## HISTORIC AND DESIGN REVIEW COMMISSION

September 18, 2024

**HDRC CASE NO:** 2024-267  
**ADDRESS:** 2619 MCCULLOUGH AVE  
**LEGAL DESCRIPTION:** NCB 1704 BLK 12 LOT N1-2 OF 12 & 13  
**ZONING:** O-1, H  
**CITY COUNCIL DIST.:** 1  
**DISTRICT:** Monte Vista Historic District  
**APPLICANT:** Matthew Gilbert/Ortiz McKnight PLLC  
**OWNER:** ZUNIGA LAW PLLC  
**TYPE OF WORK:** Requesting a waiver, fenestration modifications  
**APPLICATION RECEIVED:** July 19, 2024  
**60-DAY REVIEW:** Waived by applicant  
**CASE MANAGER:** Claudia Espinosa

**EXHIBIT**  
**4**

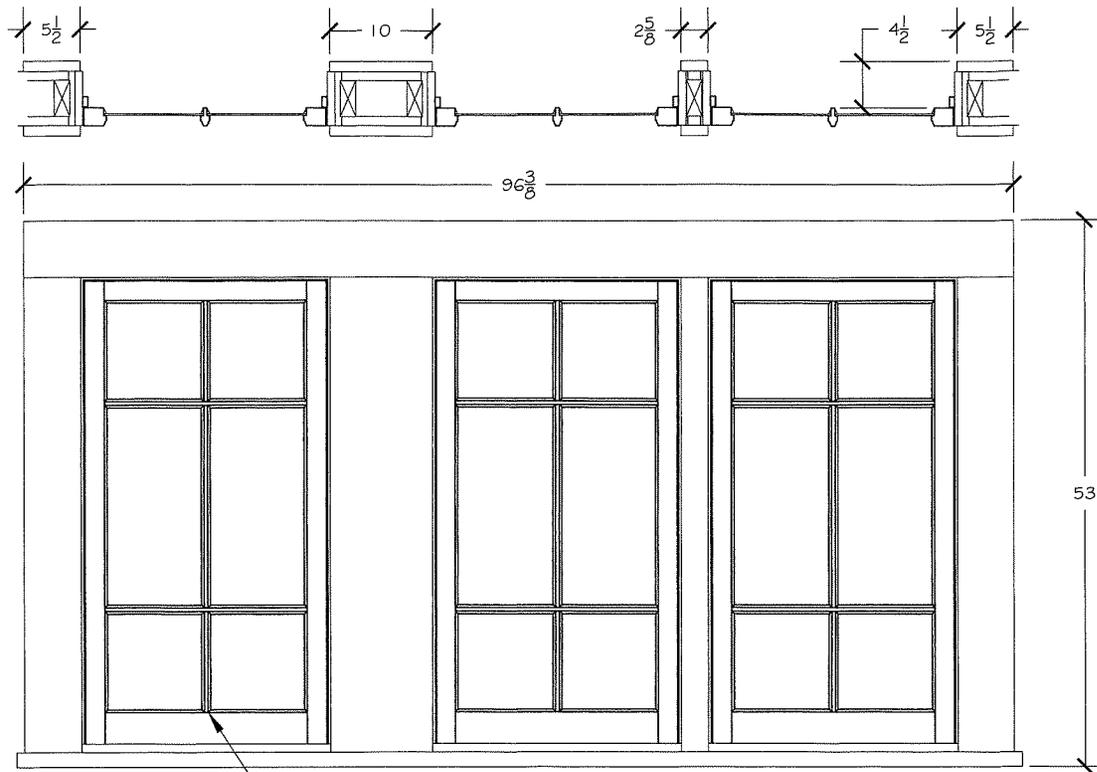
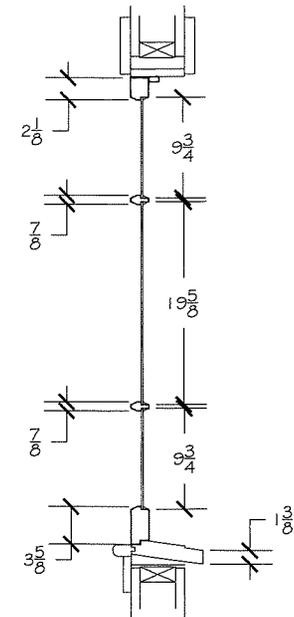
In light of staff’s analysis and recommendation, the Property Owner is in the process of reinstalling six (6) wood casement windows on the second-floor south elevation and north elevation so that the size, profile, and configuration is consistent with original construction (*see Exhibit “4”*). The property owner is also in process of reinstalling one single-hung wood window on the second-floor east elevation that was previously covered over with siding (*see Exhibit “4A”*). After additional consultation, the Property Owner is submitting this revised request for a Certificate of Appropriateness and is respectfully requesting the waiver of the one-year prohibition contemplated by §35-608(g) of the UDC. Specifically, the Property Owner is requesting to leave in place the five (5) replacement windows located on the first-floor south elevation and install new wood window screens over the top of each replacement window to exhibit the original wood character (*see Exhibit “5”*).

**EXHIBIT**  
**5**

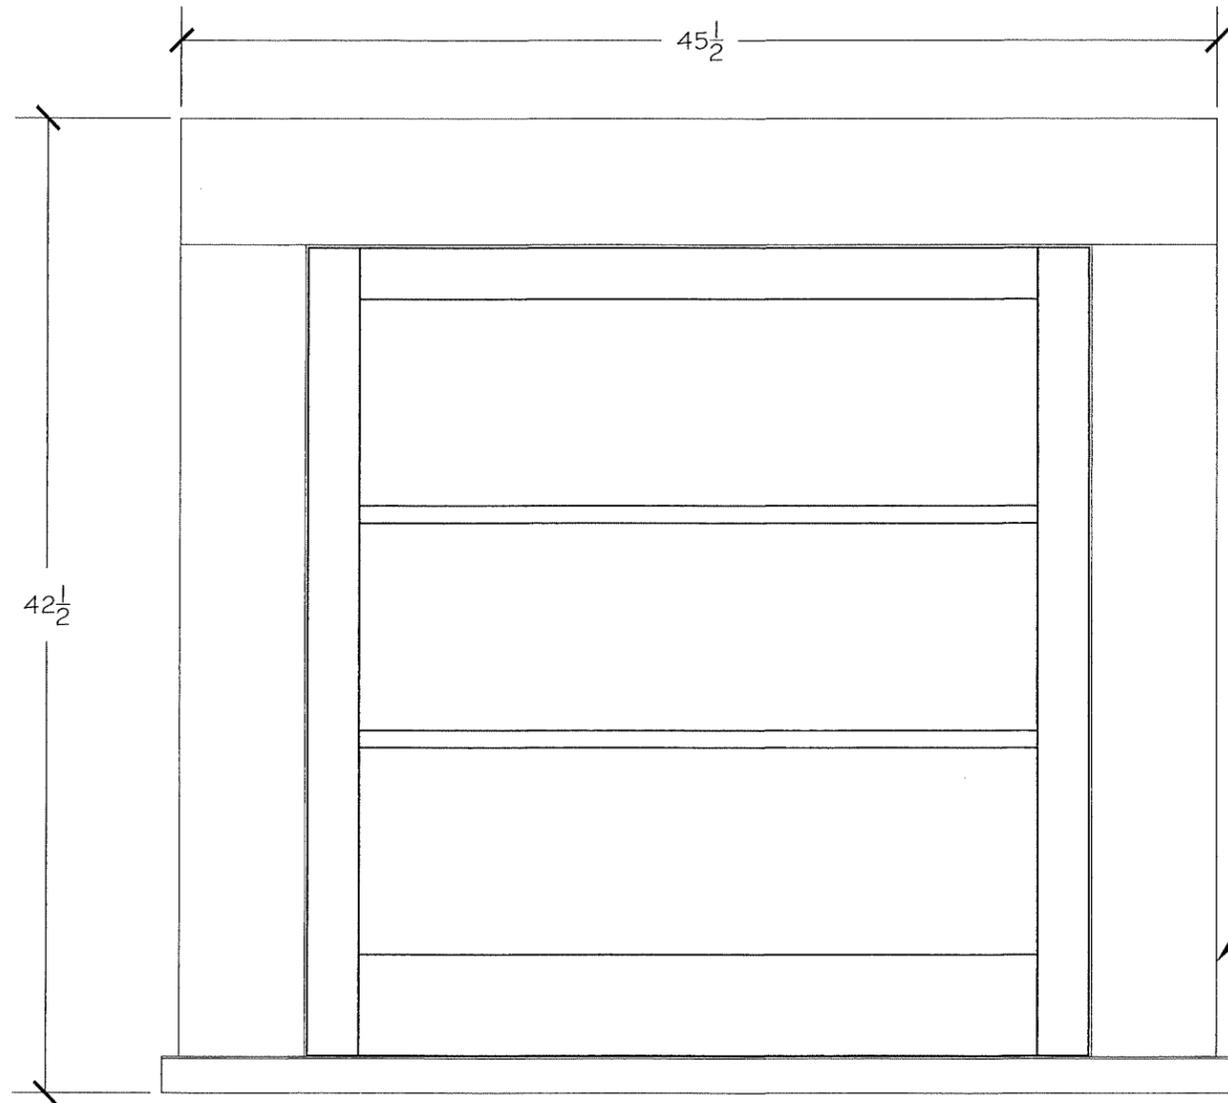
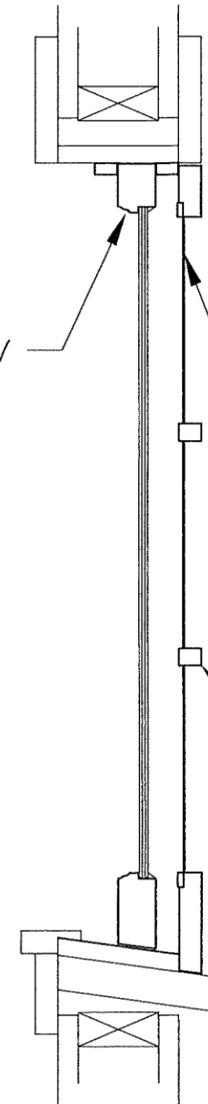
d. WINDOW OPENING MODIFICATION (SOUTH FACADE) – The applicant has proposed to replace five (5) window openings on the south façade and shorten the overall size of two of the openings. As a revision to the original proposal, the applicant has proposed to install wood window screens onto the replacement windows. The Guidelines for Exterior Maintenance and Alterations 6.A.i. notes that historic window and door openings should be preserved and discourage the modification of window sizes. It is unclear if the windows at this location were original prior to their removal; sash windows were likely the original condition on this facade. Similar, smaller sashed windows are located on the north facade and may be used as a reference. Staff finds that modifications to these openings are generally appropriate provided that any replacement windows are consistent with the Guidelines. The installed fixed windows are not consistent with the Guidelines. The applicant has proposed wood screens to disguise their appearance.

- i. Approval to replace the five windows on the south facade with the stipulation that appropriate one-over-one sash windows are installed instead of fixed windows based on finding d. The proposed window screens are appropriate and may be installed regardless of commission disposition regarding the window product. If the HDRC approves retention of the fixed windows, then staff recommends the window screens be required.
